Inspection Report Summary

Inspection Report

Facility: Loudoun Maintenance Facility

Machine: Poitras Band Saw

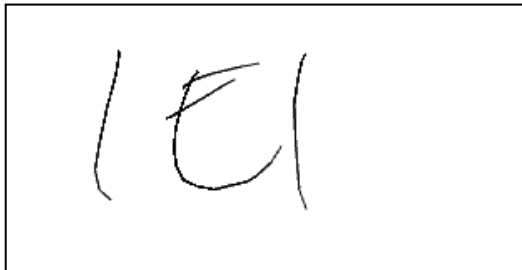
Activity/Tasks	Hazards	Corrective Action	Pass/Fail	Severity	Exposure	Avoidance	Total	Current Safeguards	Recommended Improvements
Cut part	Laceration, amputation from blade	2026 Inspections - Replace blade guard to fully cover unused portion of blade 	Fail	2	2	2	PR1 8	Adjustable guard	
Operate machine	Entangle, crush in power transmission		Pass	2	2	2	PR1 8	Secured fixed guard	
Third party access	Amputation from blade		Pass	2	2	2	PR1 8	Blade guard and hazard markings on floor
